Maule Aircraft Corporation

SERVICE LETTER #49

SUBJECT: New Flap Ratchet.

AIRCRAFT AFFECTED: MAULE Model M-5-180C, Ser. No. 8001C thru 8022C.

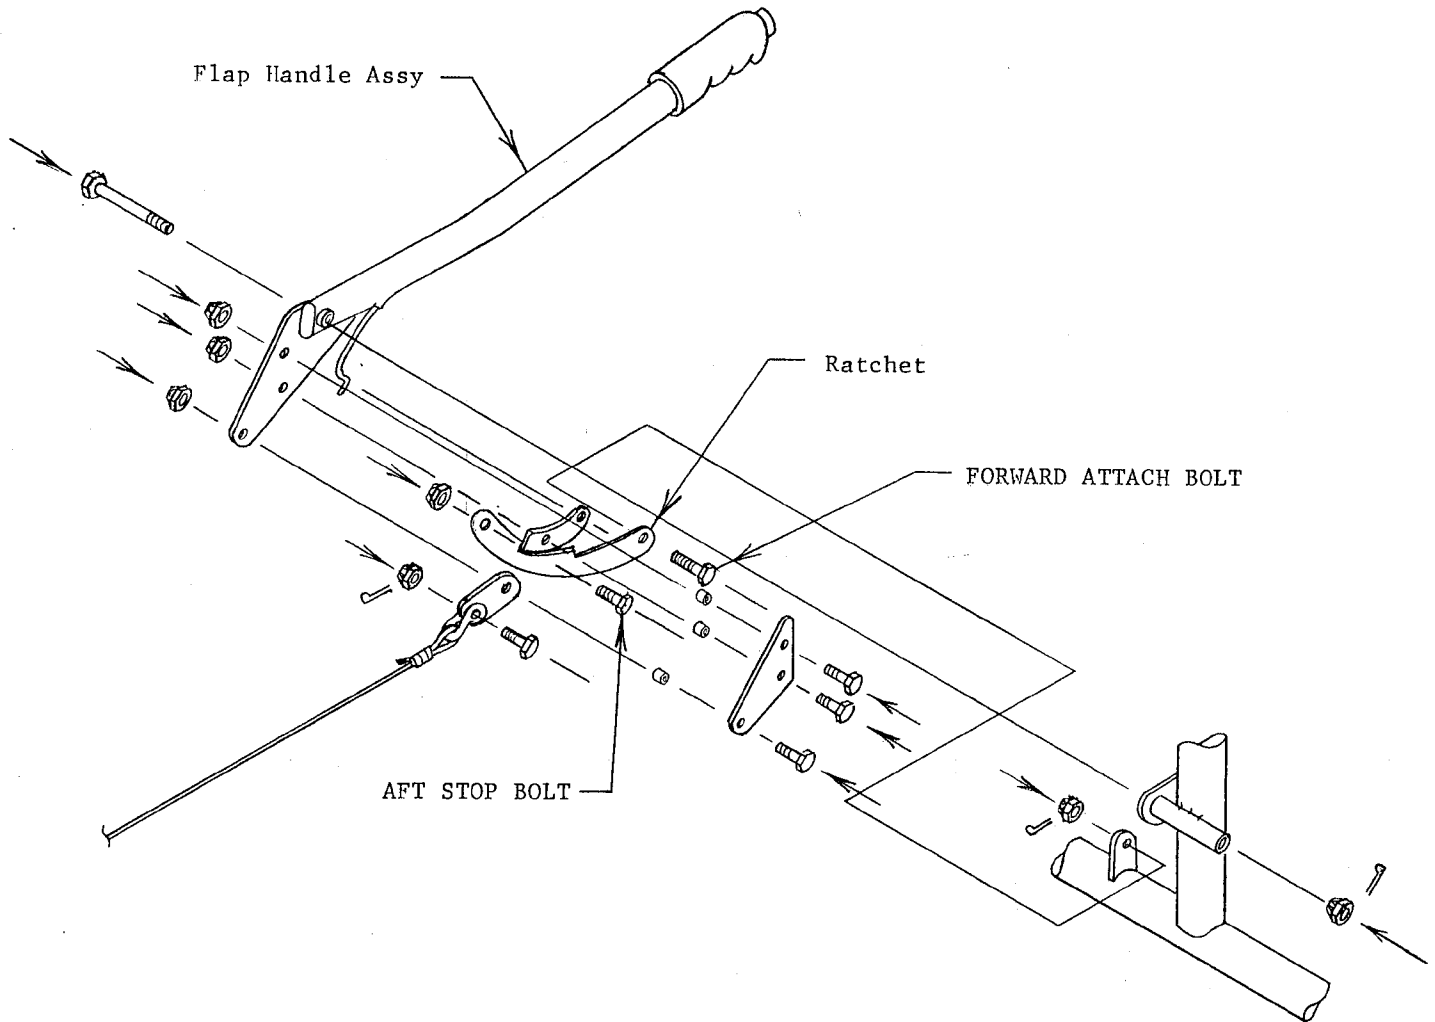
1. Remove left front seat.
2. Remove control cover (ref. Item 6, Group C-4 of Parts Catalog)
3. Remove old ratchet: (See Sketch on page 2)
 - (a) Remove forward ratchet attach bolt and nut.

- (b) Remove aft stop bolt and nut.
 - (c) Slide ratchet forward thru plates of flap handle assembly.
4. Install new ratchet:
 - (a) Slide ratchet aft thru plates of flap handle assembly.

- (b) Install forward attach bolt and nut and secure with cotter pin.
 - (c) Install aft stop bolt and nut removed from old ratchet.
NOTE: 20°-40° ratchet has forward stop bolt and nut deleted.
